FINDING OF NO SIGNIFICANT IMPACT FOR THE PROPOSED TWENTY-NINE PALMS BAND OF MISSION INDIANS FEE-TO-TRUST AND GAS STATION/CONVENIENCE STORE PROJECT

RE: Twentynine Palms Gas Station/Convenience Store

Letter 1 – City of Twentynine Palms

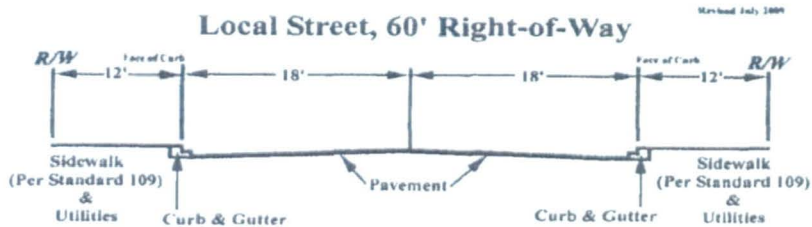
1. A scale was not identified on the site plan.
2. The site plan is missing street centerlines, travel lanes, edge of pavement, topography, and conditions on the opposite side of the road to allow for a proper assessment of transportation impacts.

The commenter remarks that the site plan for the Proposed Action is missing certain site specifications such as, a scale, travel lanes, edge of pavement, and street centerlines. The Site Plan utilized in the EA is a preliminary site plan for purposes of the prepared EA. A Final Site Plan that includes such specifications will be developed during Final Design of the project and prior to construction. The Tribe will coordinate with the City of Twentynine Palms (City) regarding the Final Site Plan when it is prepared.
